HISTORIC AND DESIGN REVIEW COMMISSION

HDRC CASE NO: 2018-350
ADDRESS: 555 CLUB DR
553 CLUB DR
LEGAL DESCRIPTION: NCB 6757 BLK G LOT 35 N 25 FT OF 34
ZONING: MF-33, H
CITY COUNCIL DIST.: 7
DISTRICT: Monticello Park Historic District
TYPE OF WORK: Window replacement
APPLICATION RECEIVED: July 09, 2018
60-DAY REVIEW: September 08, 2018
REQUEST:

The applicant is requesting a Certificate of Appropriateness for approval to replace 9 metal casement windows with vinyl windows.

Front

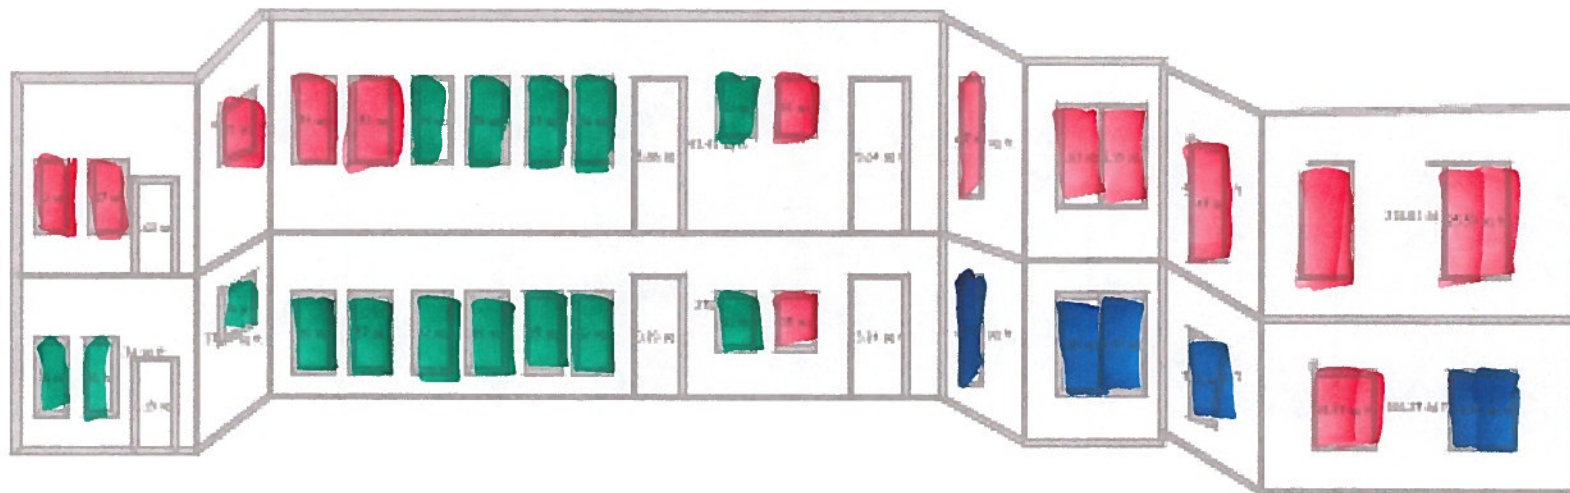
previously replaced

currently requesting approval to replace

old casement

Back side

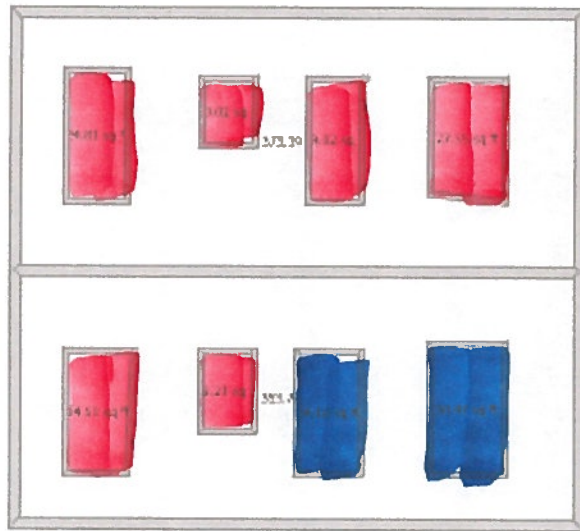
previously replaced

currently requesting approval to replace

old casement

Left SIDE

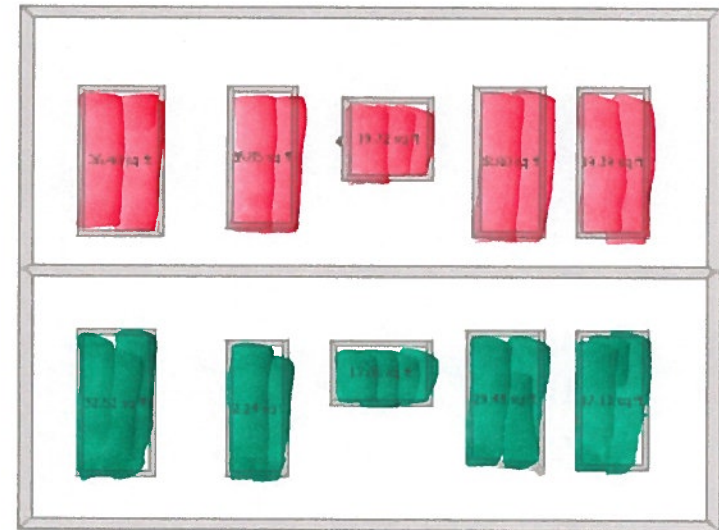
previously replaced

currently requesting approval to replace

old casement
